Re: Niagara Mohawk Power Corporation  
Nine Mile Point Nuclear Station,  
Unit No. 1  
Docket No. 50-220

APPLICATION FOR AMENDMENT  
TO  
OPERATING LICENSE

Proposed Changes to Technical Specifications

Figure 6.2-1  
Nine Mile Point Nuclear Station  
Management Organization Chart

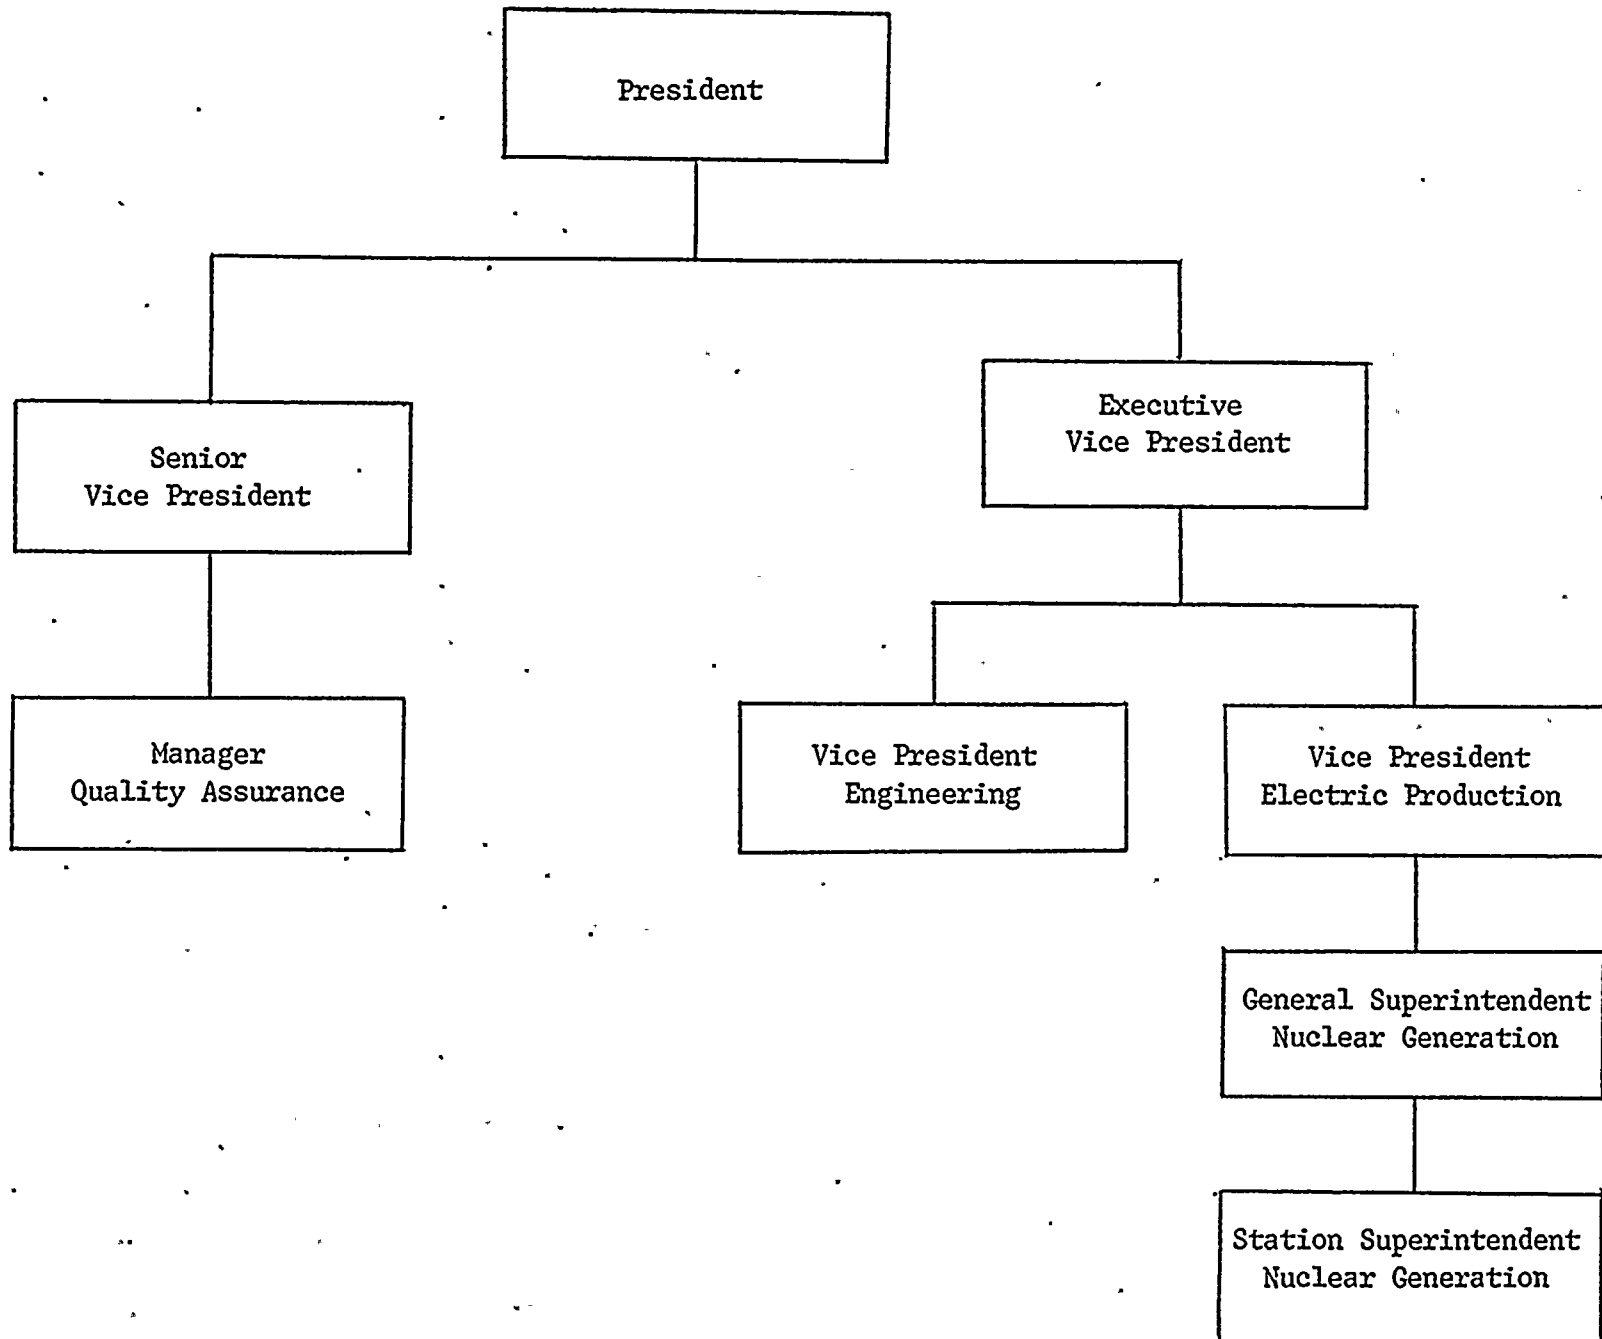
Pursuant to Section 50.90 of the regulations of the Nuclear Regulatory Commission, Niagara Mohawk Power Corporation, holder of Facility Operating License No. DPR-63, hereby requests that Sections 6.5.1.2, 6.5.1.6, 6.5.1.7, 6.5.1.8, 6.5.2.2, 6.5.2.8, 6.5.2.9, 6.5.2.10, 6.6.1, 6.7.1 and Figures 6.2-1 and 6.2-2 of the Technical Specifications and Bases set forth in Appendix A to that License be amended. The proposed changes have been concurred with by the Site Operations Review Committee and the Safety Review and Audit Board.

- 1) eliminate the James A. FitzPatrick Nuclear Power Plant from the Nine Mile Point Nuclear Site Organization (Figure 6.22)
- 2) to eliminate representation of the Power Authority of the State of New York from the Site Operations Review Committee and Safety Review and Audit Board and
- 3) to reflect changes in the Niagara Mohawk onsite and offsite organizations.

These proposed changes reflect the changes in operating responsibility for the James A. FitzPatrick Nuclear Power Plant. These changes also reflect current Niagara Mohawk onsite and offsite organization for facility management. It is expected that the new organization will improve facility management and provide for more effective reporting. The Site Operations Review Committee and the Safety Review and Audit Board will retain adequate membership to provide the expertise required by ANSI N18.7-1972.
